**RFP-DPW-2025-0006**

**Cortez Blvd (SR 50) Pump Station Replacement Project**

**ADDENDUM #8**

**UPDATED Electrical Plans**

**01 POWER ONE-LINE DIAGRAM**  
SCALE: NONE

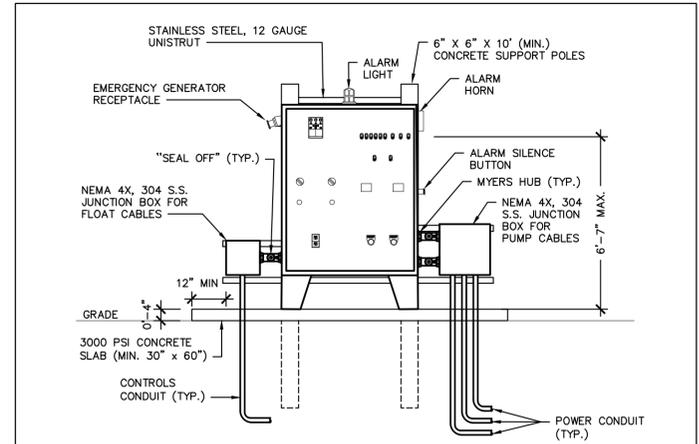
DATE	REV. BY/REV. NO.	REVISION
4/21/25	AE 1	ADDENDUM 1
